REVISION #4

REVISION	DATE	COMMENTS
4	02/03/26	CONTRACTOR REVISIONS

PROJECT:
CORNISH LIBRARY & COMMUNITY CENTER
226 NH-120
CORNISH FLAT, NH 03746

ISSUED:
CONSTRUCTION DOCUMENTS

1 ELECTRICAL BASEMENT POWER & DATA PLAN
3/16" = 1'-0"

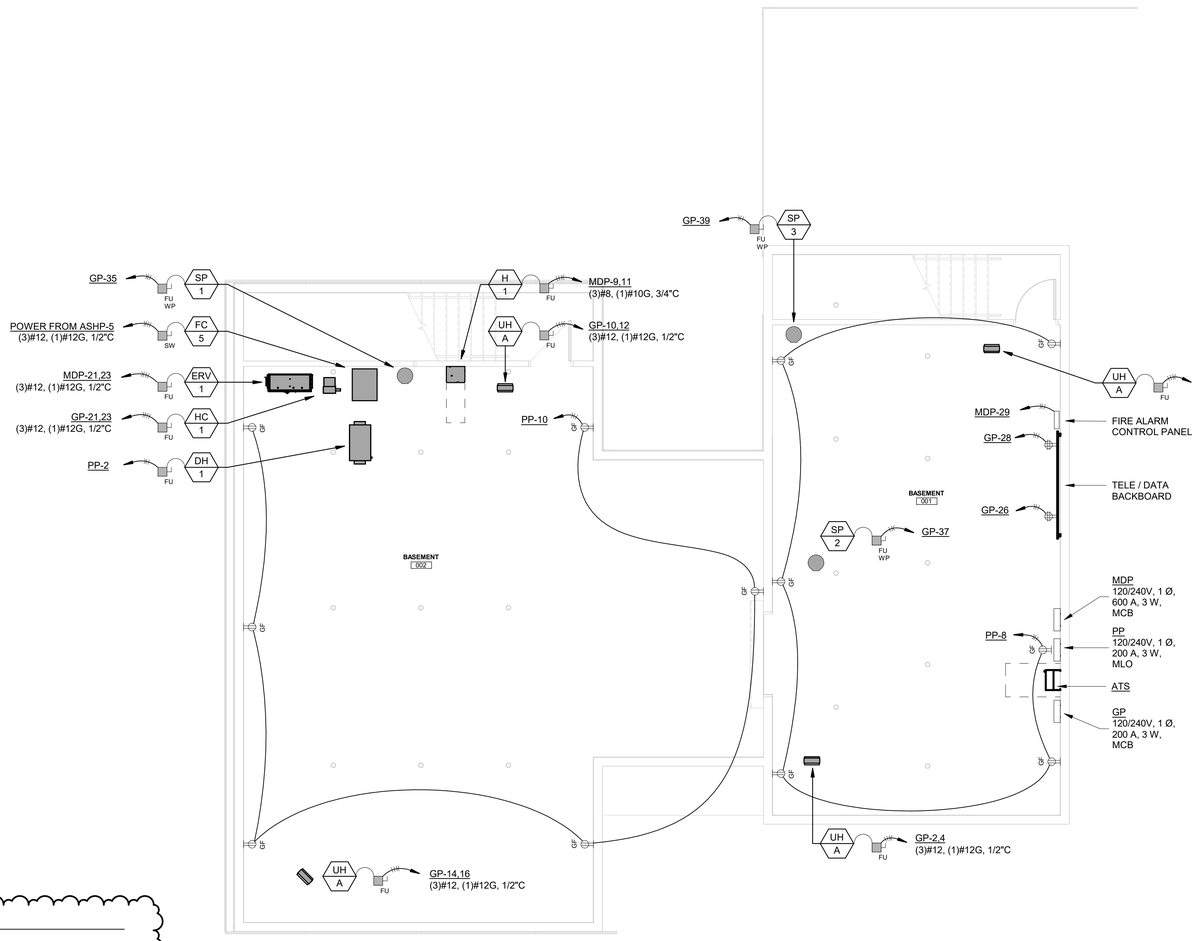
1.) ASHP SYSTEMS REVISED PER ALTERNATE EQUIPMENT SUBMITTAL.

2.) CIRCUIT BREAKERS, WIRES, & CONDUITS FOR ASHP SYSTEMS HAVE BEEN MODIFIED TO ACCOMODATE ASHP REVISION.

3.) EXISTING GENERATOR IS NO LONGER ADEQUATELY SIZED FOR ALTERNATIVE ASHP EQUIPMENT. PROVIDE 48kW GENERATOR IN LIEU OF RE-USING EXISTING.

4.) GENERATOR PANEL GP HAS BEEN INCREASED TO 200 AMP TO ACCOMODATE ASHP REVISION.

1 ELECTRICAL FIRST FLOOR POWER & DATA PLAN
3/16" = 1'-0"

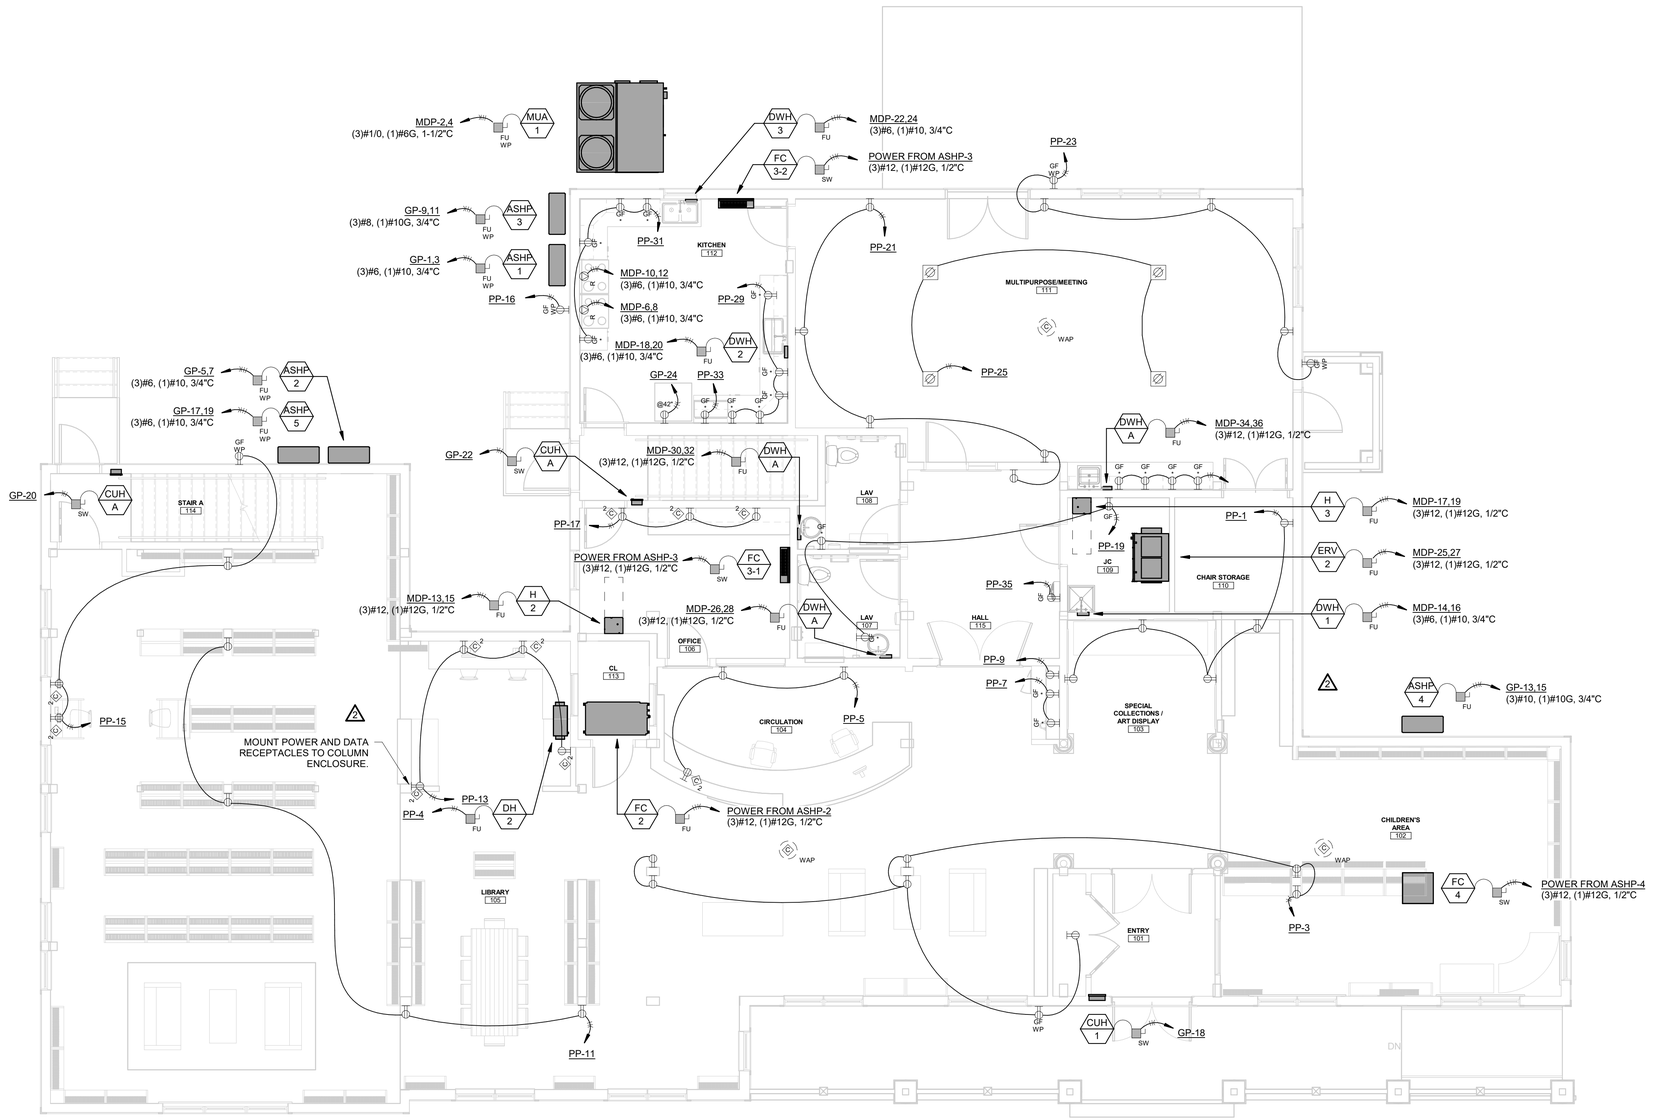
1.) ASHP SYSTEMS REVISED PER ALTERNATE EQUIPMENT SUBMITTAL.

2.) CIRCUIT BREAKERS, WIRES, & CONDUITS FOR ASHP SYSTEMS HAVE BEEN MODIFIED TO ACCOMODATE ASHP REVISION.

3.) EXISTING GENERATOR IS NO LONGER ADEQUATELY SIZED FOR ALTERNATIVE ASHP EQUIPMENT. PROVIDE 48kW GENERATOR IN LIEU OF RE-USING EXISTING.

4.) GENERATOR PANEL GP HAS BEEN INCREASED TO 200 AMP TO ACCOMODATE ASHP REVISION.

1 ELECTRICAL SECOND FLOOR POWER & DATA PLAN
3/16" = 1'-0"

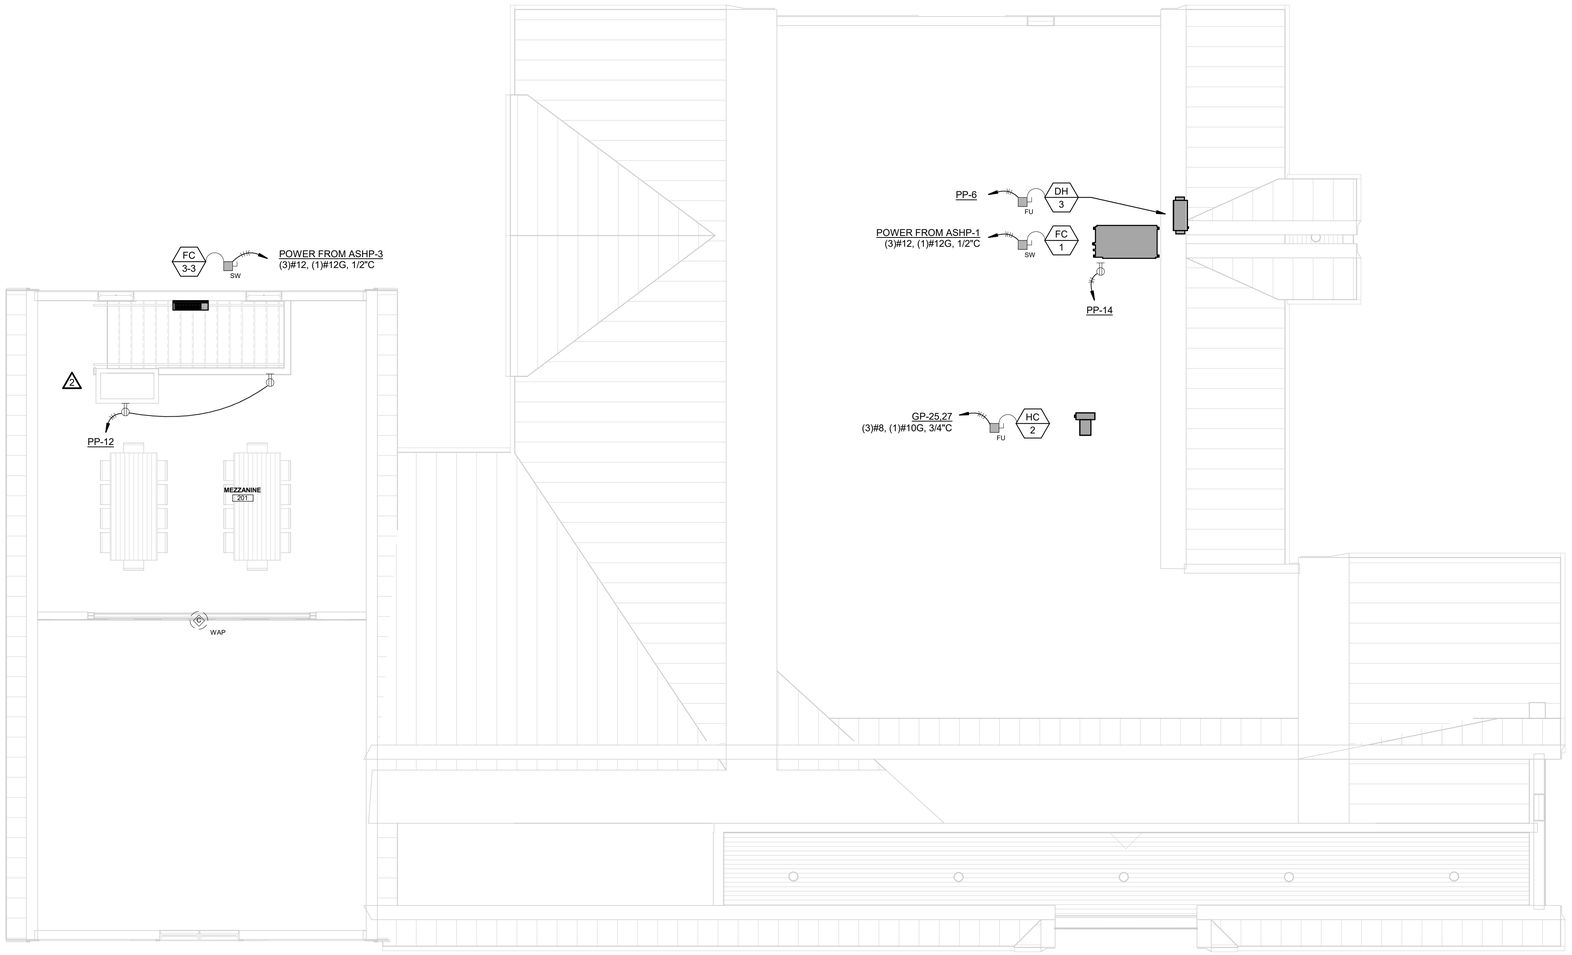
1.) ASHP SYSTEMS REVISED PER ALTERNATE EQUIPMENT SUBMITTAL.

2.) CIRCUIT BREAKERS, WIRES, & CONDUITS FOR ASHP SYSTEMS HAVE BEEN MODIFIED TO ACCOMODATE ASHP REVISION.

3.) EXISTING GENERATOR IS NO LONGER ADEQUATELY SIZED FOR ALTERNATIVE ASHP EQUIPMENT. PROVIDE 48kW GENERATOR IN LIEU OF RE-USING EXISTING.

4.) GENERATOR PANEL GP HAS BEEN INCREASED TO 200 AMP TO ACCOMODATE ASHP REVISION.

SECTION A-A
SECONDARY CONDUIT TRENCH DETAIL
NOT TO SCALE

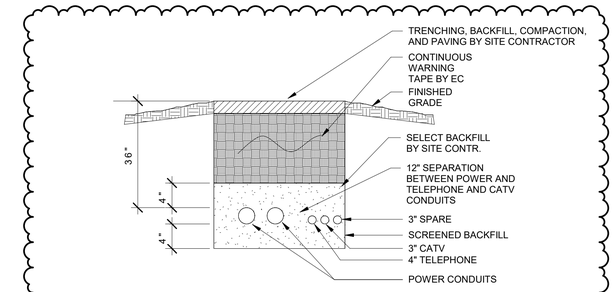
5.) SECONDARY TRENCH SECTION DETAIL HAS BEEN ADDED TO SHOW TELEPHONE AND DATA CONDUITS TO BUILDING PER RFI #24.

1 MECHANICAL BASEMENT PLAN
3/16" = 1'-0"

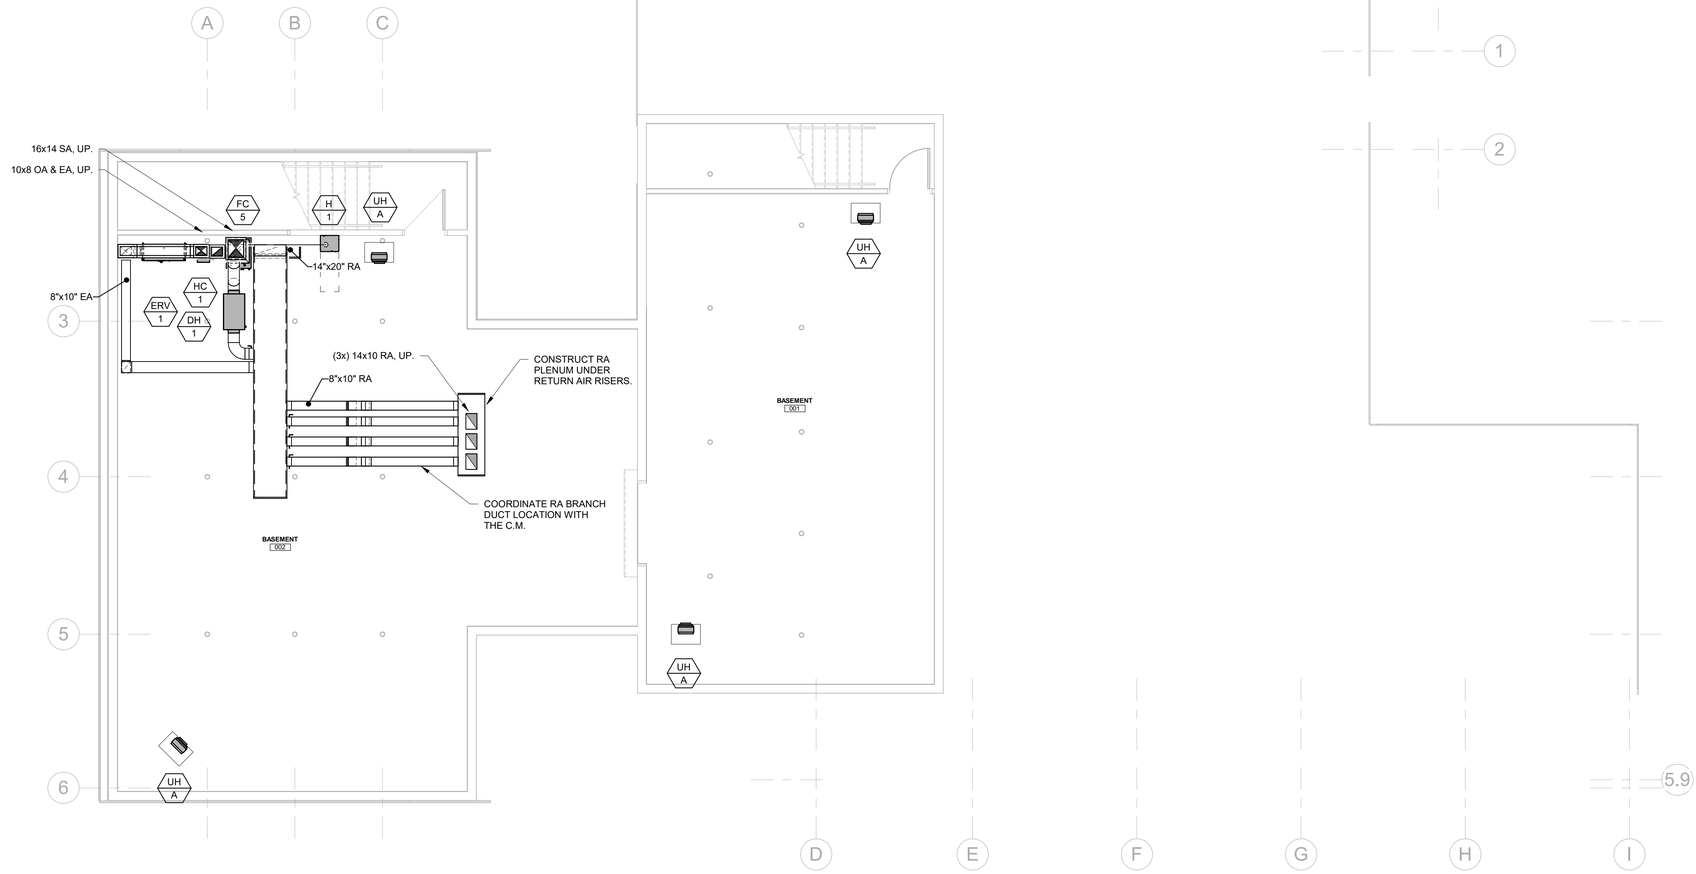
1.) ASHP SYSTEMS REVISED PER ALTERNATE EQUIPMENT SUBMITTAL.

2 MECHANICAL LEVEL 1 FLOOR PLAN
3/16" = 1'-0"

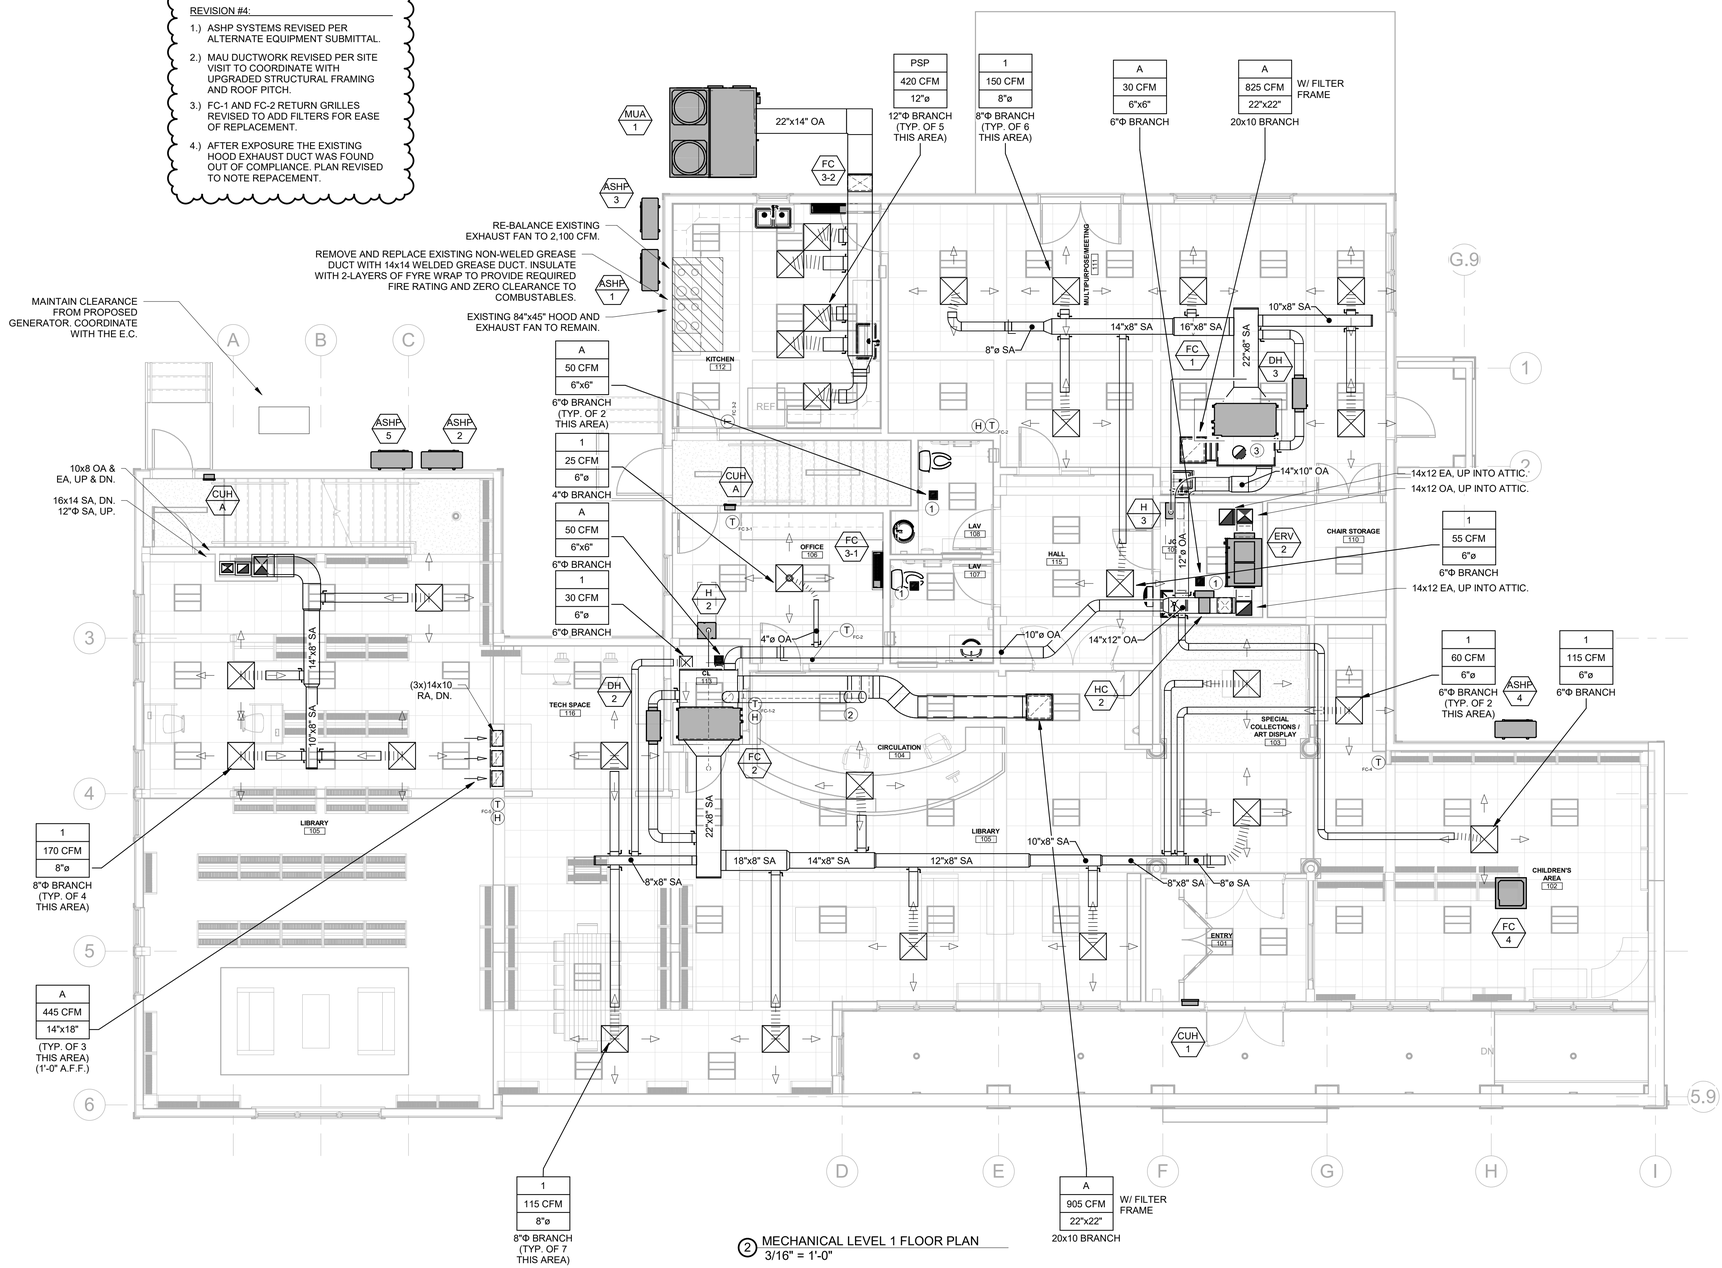
1.) ASHP SYSTEMS REVISED PER ALTERNATE EQUIPMENT SUBMITTAL.

2.) MAU DUCTWORK REVISED PER SITE VISIT TO COORDINATE WITH UPGRADED STRUCTURAL FRAMING AND ROOF PITCH.

3.) FC-1 AND FC-2 RETURN GRILLES REVISED TO ADD FILTERS FOR EASE OF REPLACEMENT.

4.) AFTER EXPOSURE THE EXISTING HOOD EXHAUST DUCT WAS FOUND OUT OF COMPLIANCE. PLAN REVISED TO NOTE REPACEMENT.

2 MECHANICAL LEVEL 2 FLOOR PLAN
3/16" = 1'-0"

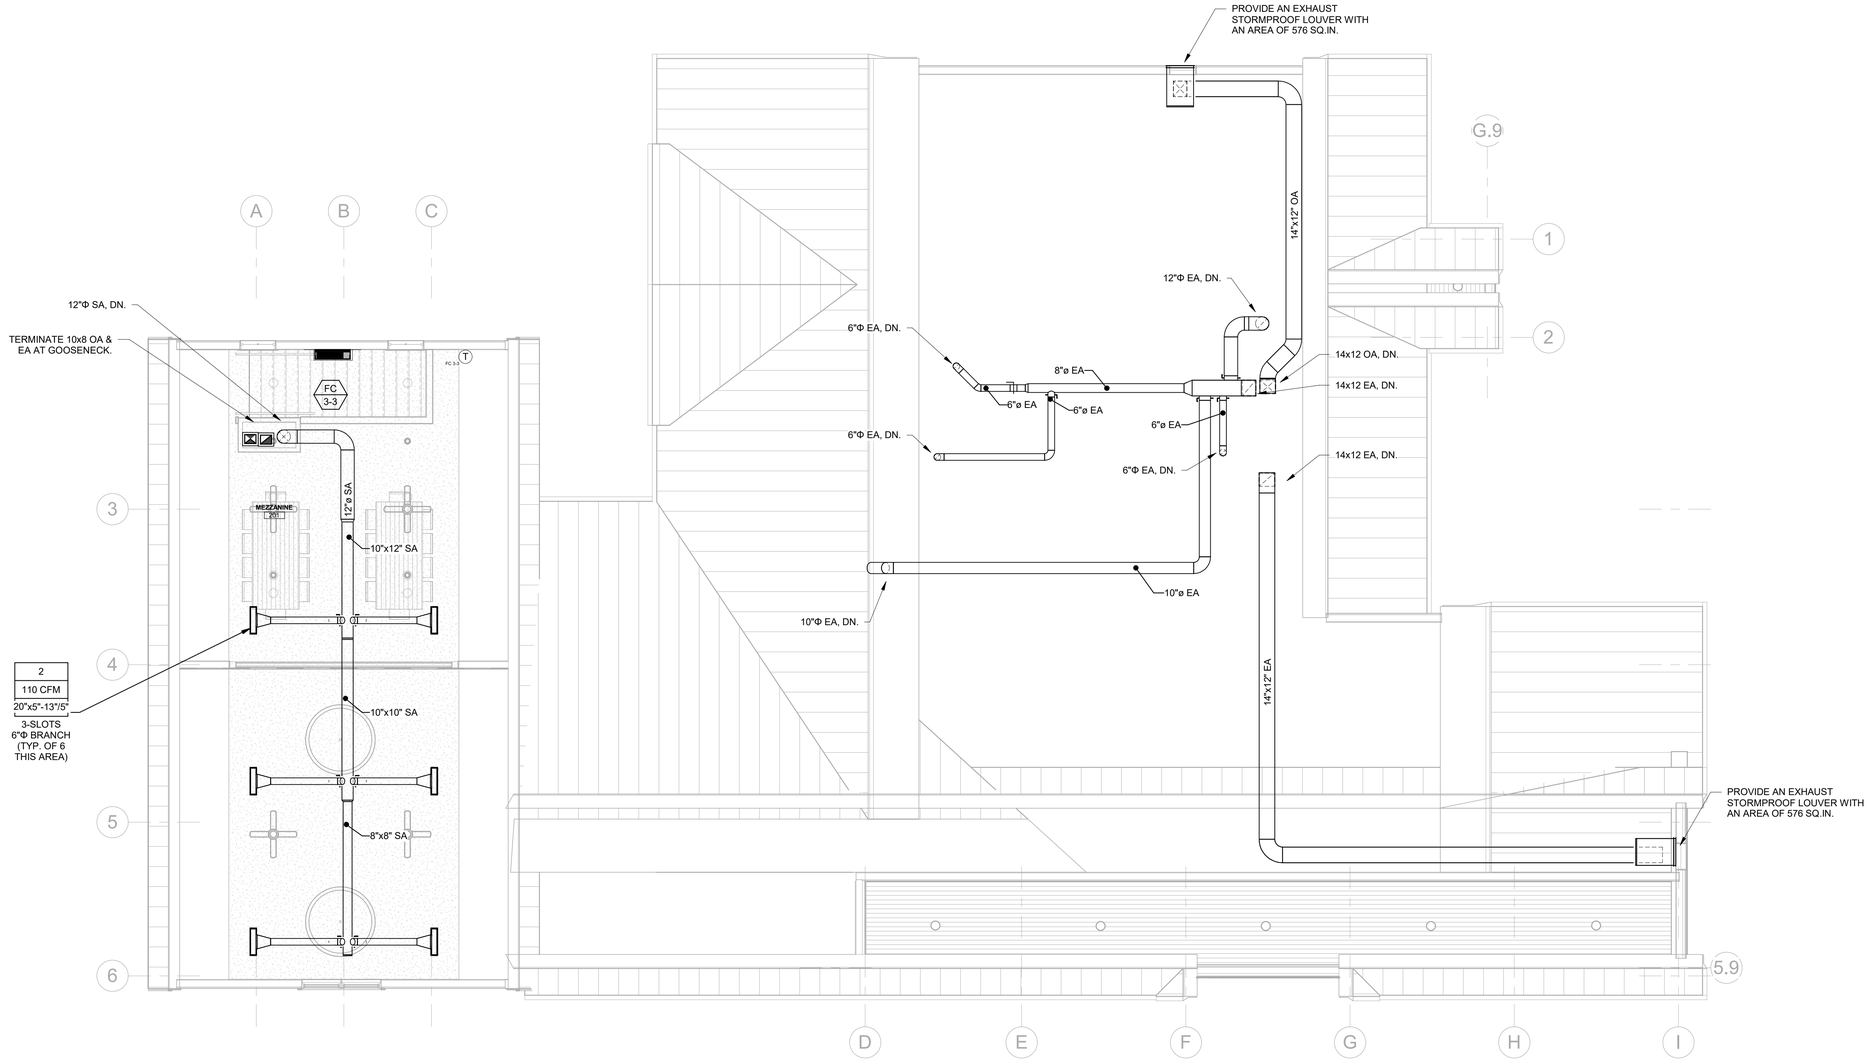
1.) ASHP SYSTEMS REVISED PER ALTERNATE EQUIPMENT SUBMITTAL.

2.) FC-5 SUPPLY DIFFUSER LENGHTS REDUCED TO COORDINATE WITH EXISTING STRUCTURE.
